Location: #24 St., Hill Rd.

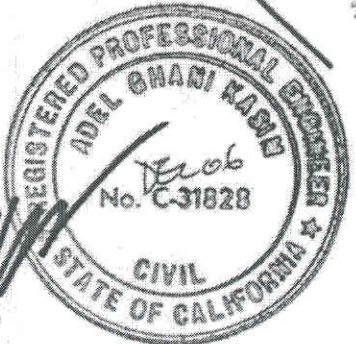
Hallenbeck Boring 1 shown in wrong location

Approx area shown by Adel Kasim 12/22/06 to be "INCIPIENT" landslide

note location of catch basin

Hallenbeck Boring 2 shown in wrong location

Hallenbeck Boring 3 shown in wrong location

15' High
Approx 2:1
Slope (Topo
pending)
